## DEVELOPMENT APPLICATION ASSESSMENT REPORT

<b>ITEM No.</b>	
<b>FILE No.</b>	DA 384/2012/1
<b>PROPERTY DETAILS</b>	2 Laguna Street, Vacluse (former Vacluse High School site)  <b>Lot &amp; DP No.:</b> LOT: 1554 DP: 820600 <b>Side of Street:</b> North-western side of Old South Head Rd North-eastern side of Laguna St <b>Site Area (m<sup>2</sup>):</b> 12,030 <b>Zoning:</b> Special Uses Existing (School)
<b>PROPOSAL:</b>	Demolition of the existing former Vacluse High School buildings and the construction of a Seniors Housing Development comprising a 227 bed residential care facility, 3 x 1 & 11 x 2 bedroom self-contained dwellings (serviced self-care housing), associated services, 99 basement parking spaces, landscaping and siteworks
<b>APPLICANT:</b>	Thinc Projects Australia Pty Ltd
<b>OWNER:</b>	Norwent 3 Pty Ltd
<b>DATE LODGED:</b>	10/09/2012
<b>AUTHOR:</b>	David Booth-Senior Assessment Officer
<b>CONSENT AUTHORITY</b>	Joint Regional Planning Panel (JRPP)

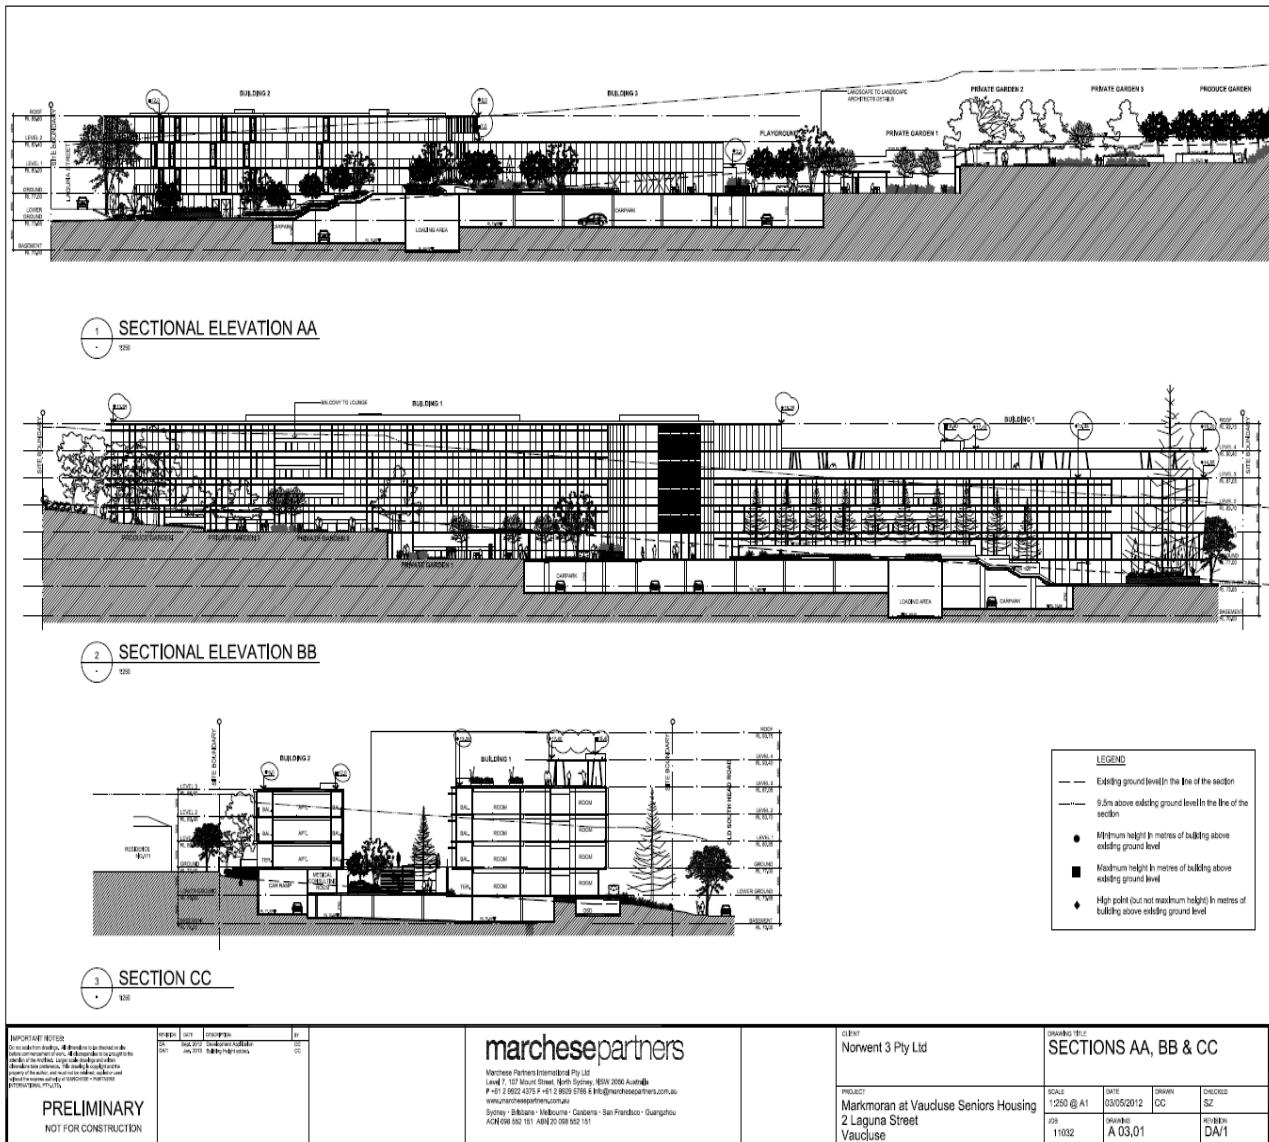
Building 1 involves a maximum height of approximately 18.4 m above the existing ground level which exceeds Council's 9.5 m height standard by as much as 8.9 m.

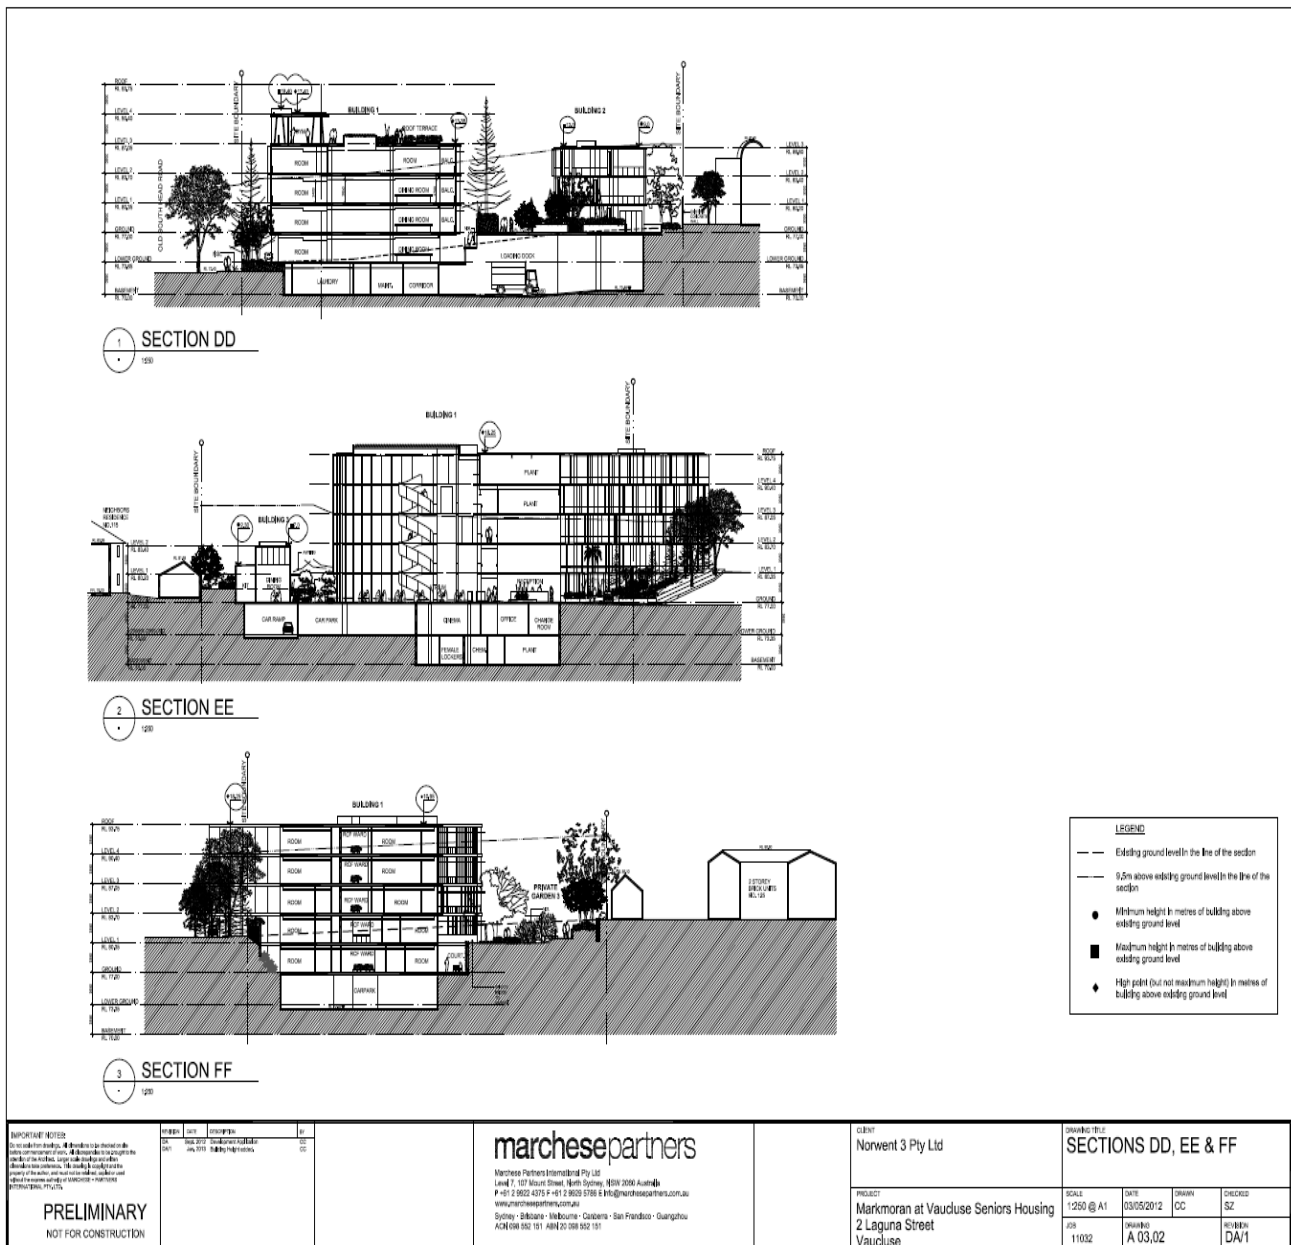
Building 2 involves a maximum building height of approximately 12 m above the existing ground level which exceeds Council's 9.5 m height standard by as much as 2.5 m.
